JOHN E. GLASGOW

June 16, 2013

Re. Application for Coastal Development Permit
ENV-2012-131-MND (revised) dated June 17, 2013, Case No. ZA-2012-130-CDP
Project at 16990 - 17000 Sunset Blvd., Pacific Palisades, CA 90272

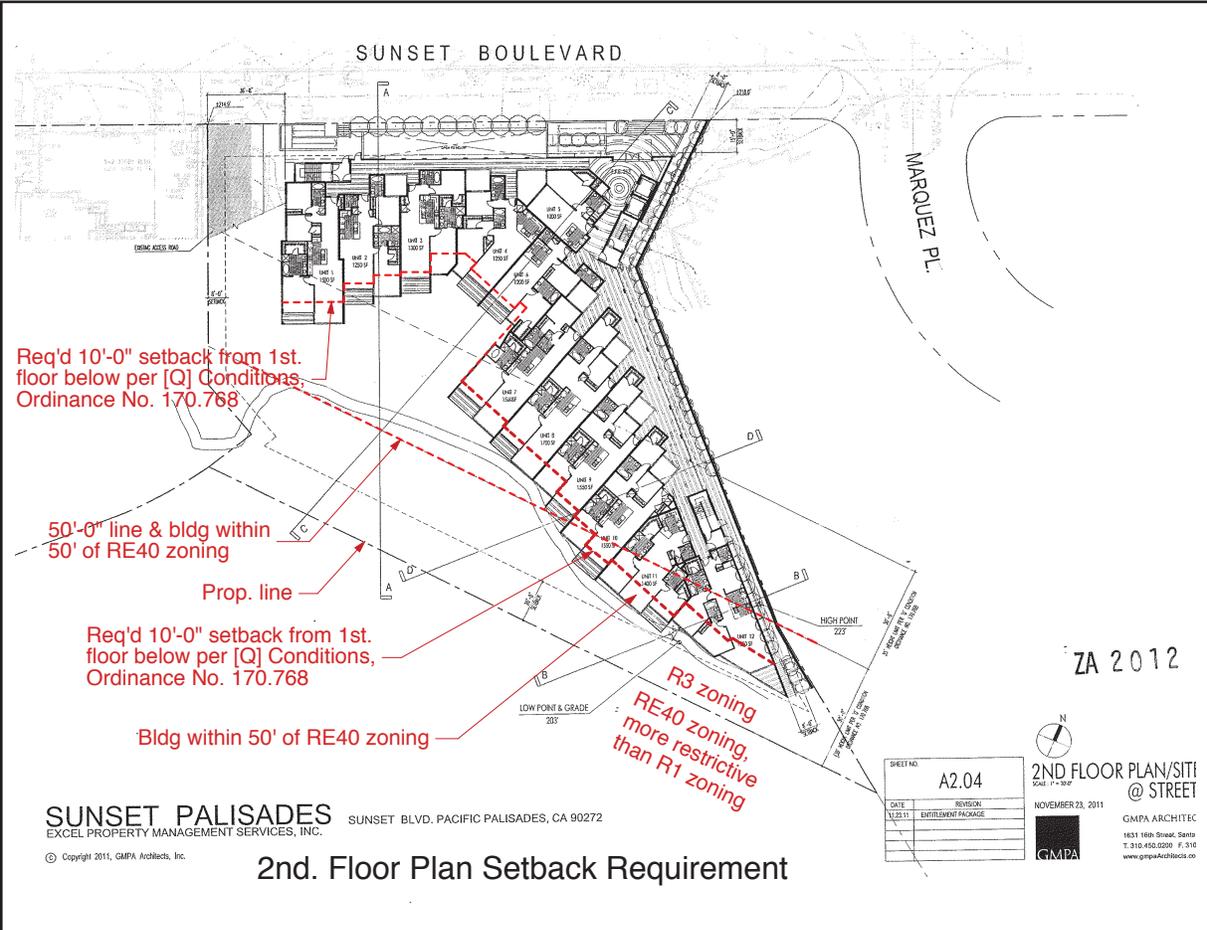
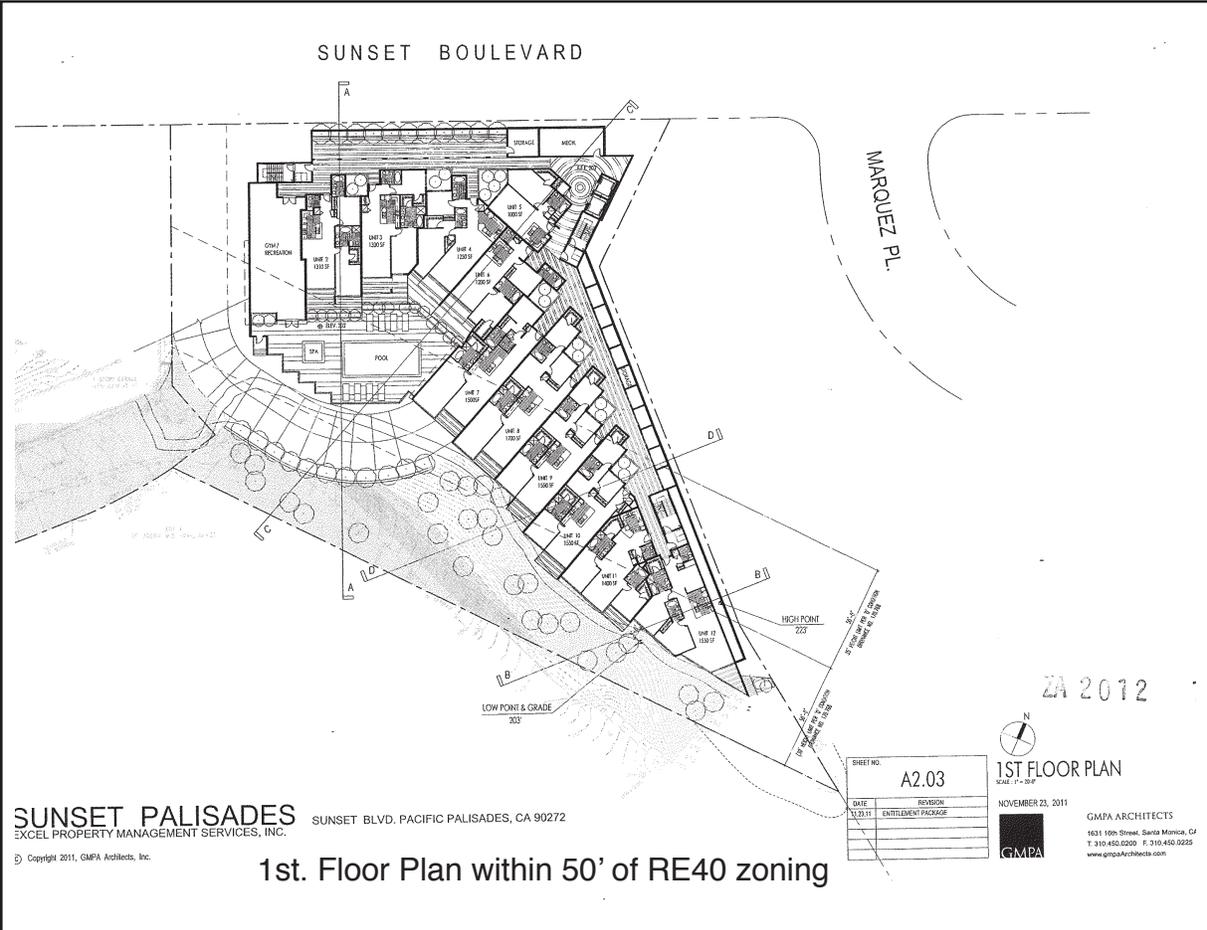
The drawing package submitted to the Department of Planning for the applicant’s Coastal Development Permit shows that the floor plan drawings for the first floor (A2.03) AND second floor (A2.04) are set back just beyond the dashed 20’-0” setback line on the south side of the property “*which is within 50 feet of a lot zoned R1 or more restrictive*” (RE40). The face of these two floors are in the same vertical plane, which violates the required second story setback of “*10 feet horizontally from the exterior wall of the first story*”. Although not documented here, this condition for this property was verified with the Planning desk at Building & Safety in West L.A. See attached drawings.

The applicant should provide an architectural north-south section of the project at the rear of the building showing the first and second floors as they dimensionally relate to the property line, the 50’-0” demarcation line and the property line for the adjacent RE40 zoned property to the south.
